# The Sizewell C Project

## 6.1 Volume 1 Introduction to the Environmental Statement Chapter 6 EIA Methodology Appendix 6B - EIA Scoping Opinion

# **SCOPING OPINION:**

## **Proposed Sizewell C Nuclear Development**

Figure 1

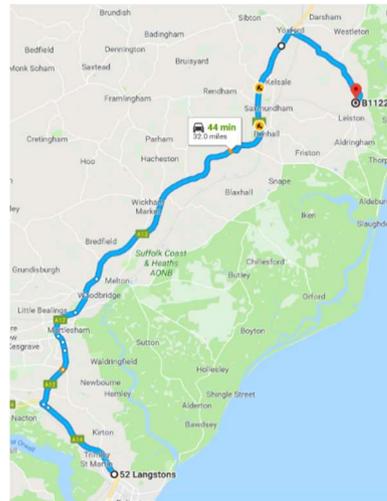
Moreover, it comes at the end of a tortuous 30-mile journey (Figure 1), from either of proposed Freight Management Facilities, on or adjacent to the A14 east of the A12 junction.

Figure 1 - Map showing Proposed alternative Route

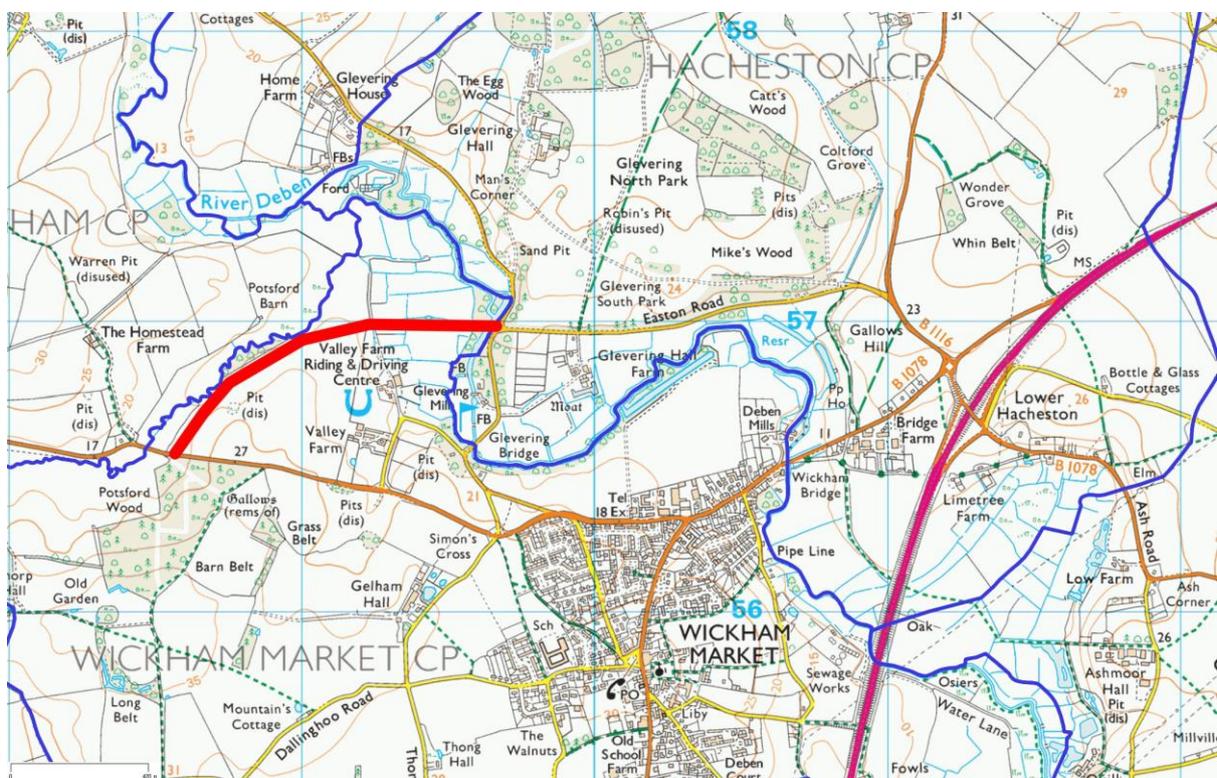
- 18.10. A possible alternative new road is shown in red below:

This alternative has the significant benefit that road users will choose this route in preference to the existing road route as it will be quicker, a better road and an easier journey. The bridge/crossing over the River Deben will not be easy as it is on a flood plain however, once built it will form an extremely positive lasting legacy for Wickham Market as it will significantly reduce current HGV traffic through the north end of Wickham Market. It is appreciated that this option is not ideal from an environmental perspective and certainly does not have universal support within the Parish Council so if EDF could propose a better diversion route then that would be ideal. Alternatively, if there are significant environmental objections, the diversion route could be temporary, thus the river valley would be returned to its natural state after the project.
